Addendum 01

PROJECT: Zane Grey Intermediate School MVHC Clinic Renovation
968 Pine Street
Zanesville, Ohio 43701

PROJECT #: 25006.02

This addendum form is a part of the Contract Documents and modifies the Bidding Documents titled "Construction Documents," dated June 17, 2025, with amendments and additions noted below.

2 AHU-1 ELEVATION AND PLAN VIEW DETAIL
M3.1 NTS

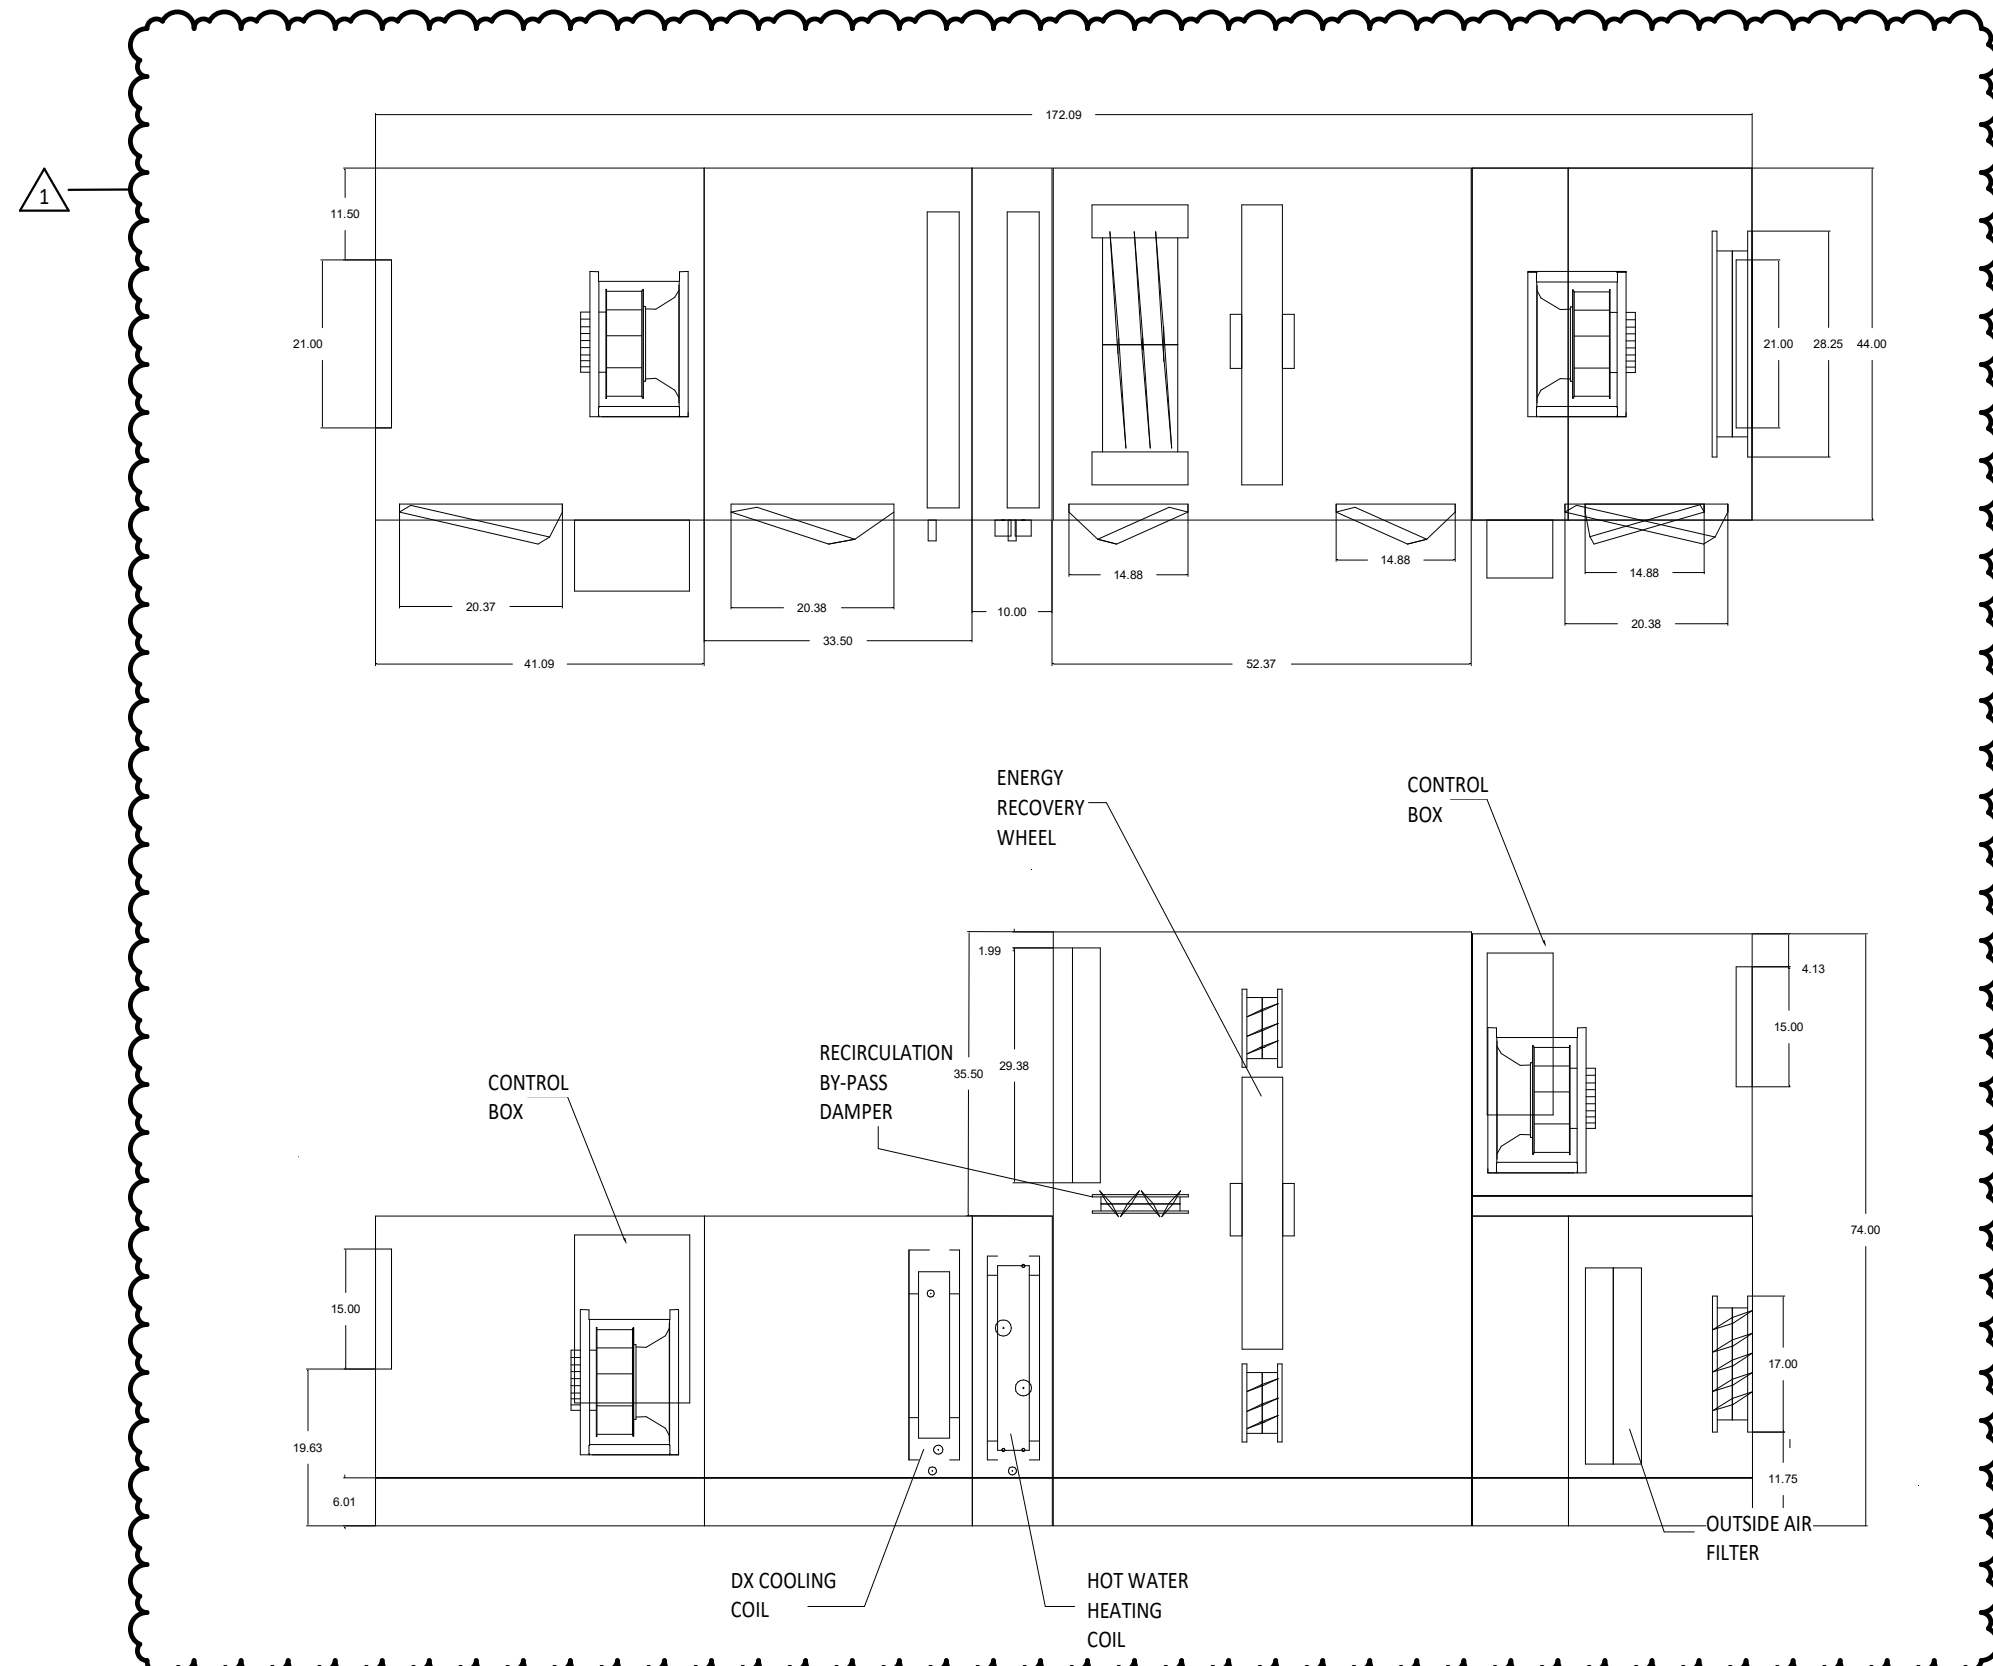
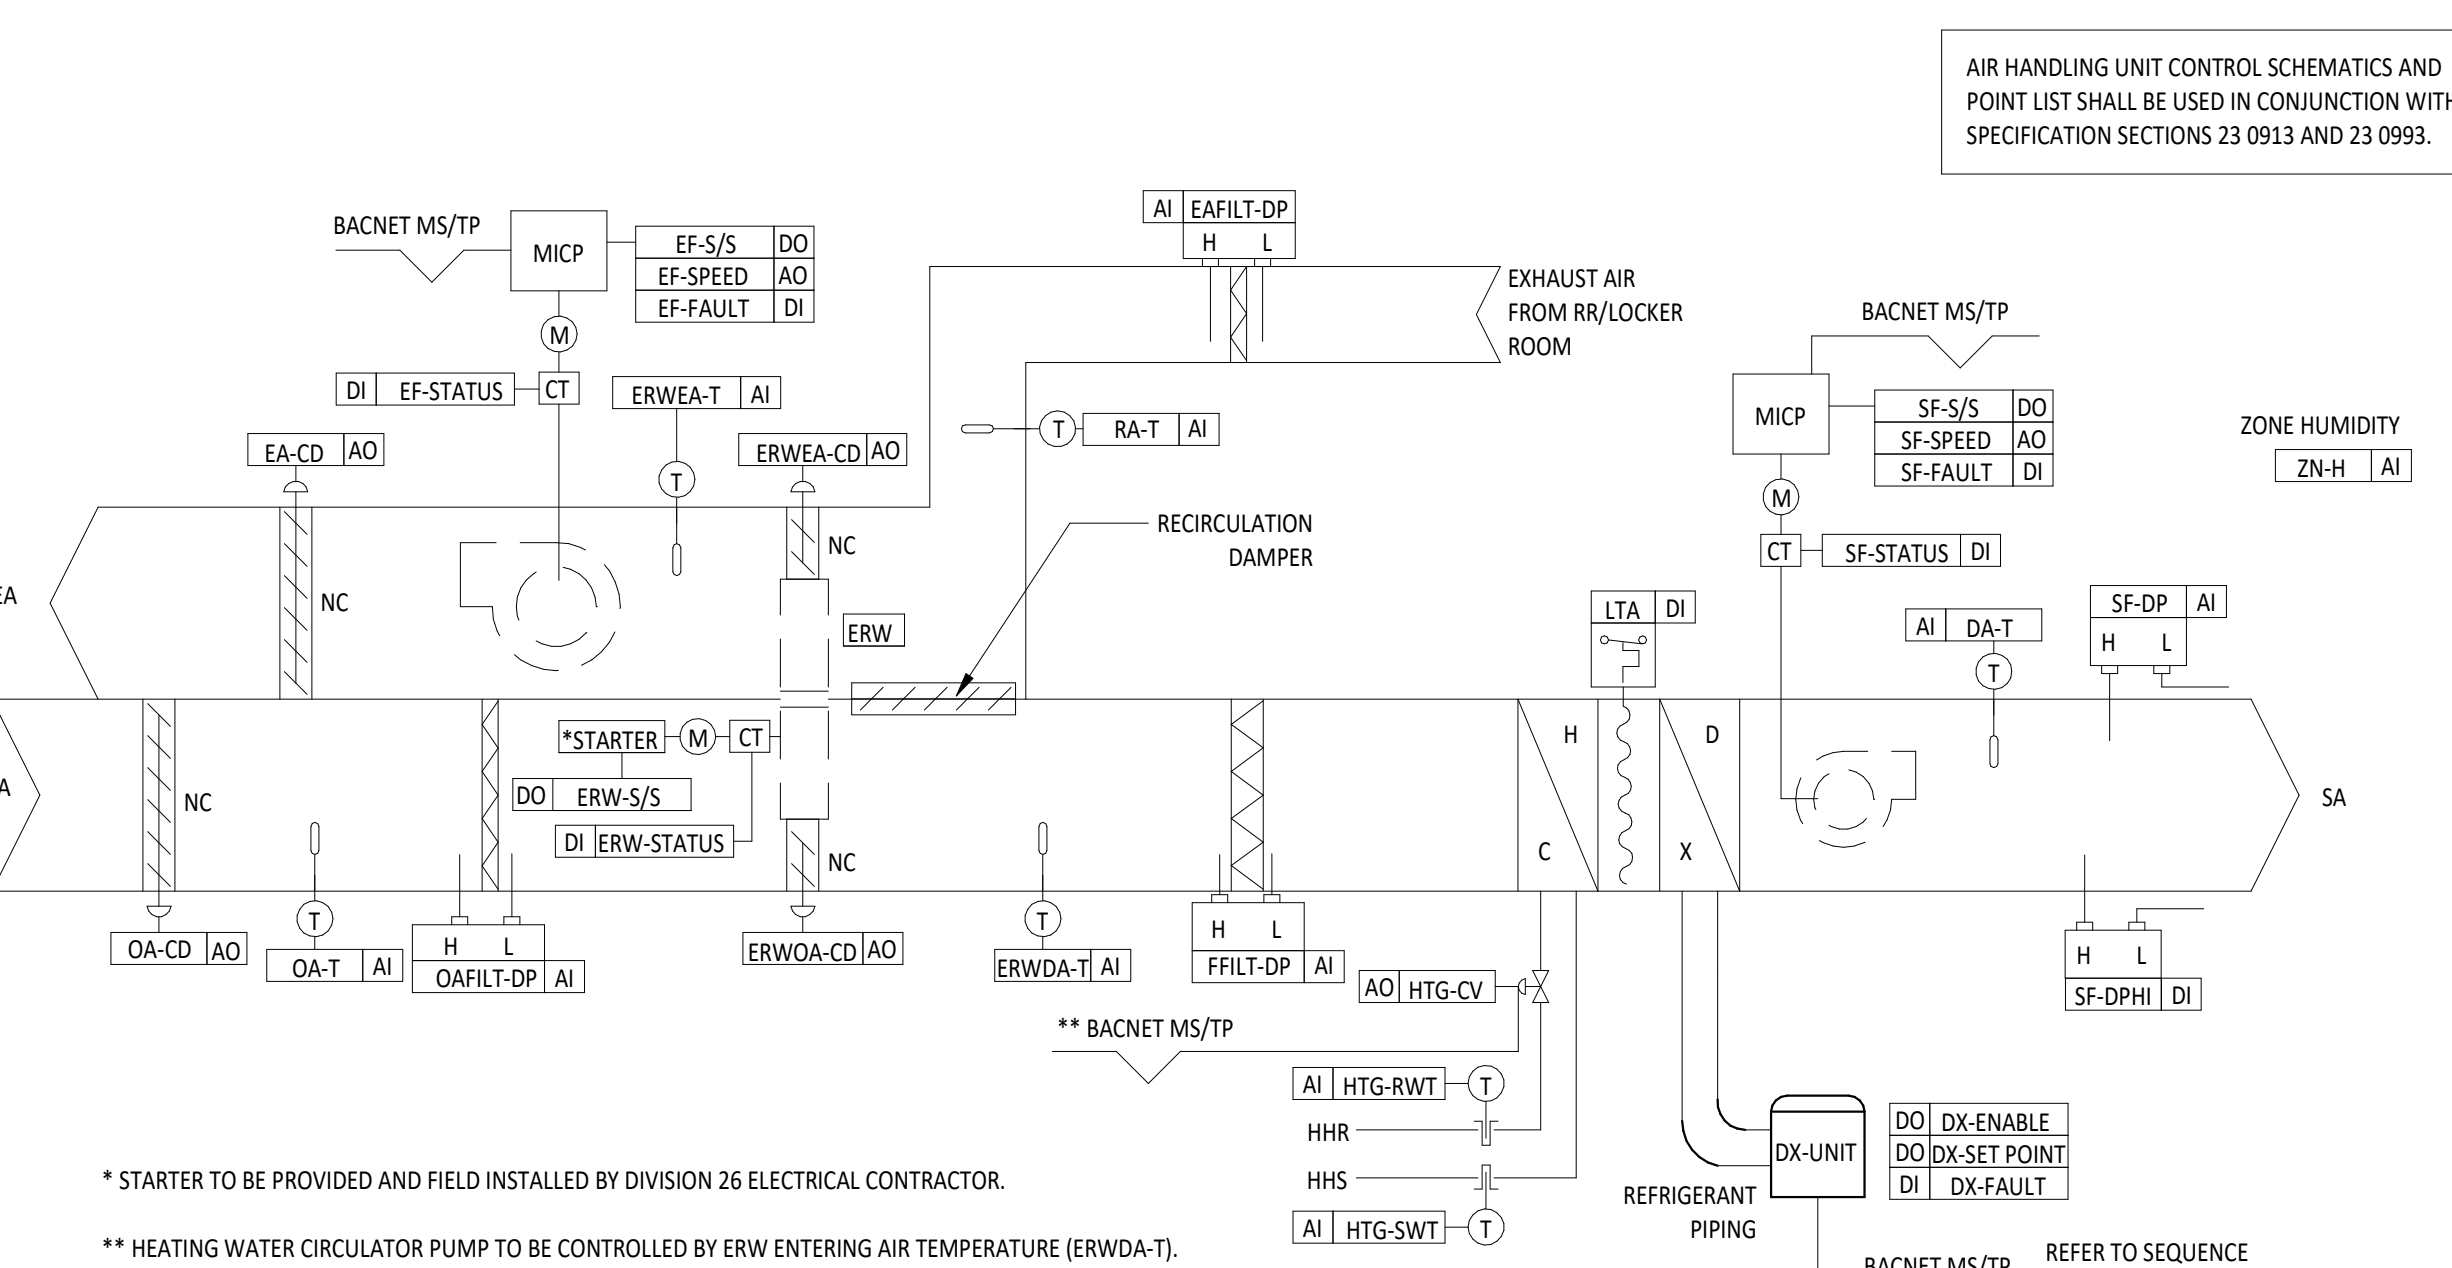
- a. Updated AHU detail
 - b. Updated AHU Control detail
 - c. Revised tagging of piping plan
5. Drawing Sheet E2.1 Electrical Plans: Detail 3 First Floor Power Plan – Unit A:
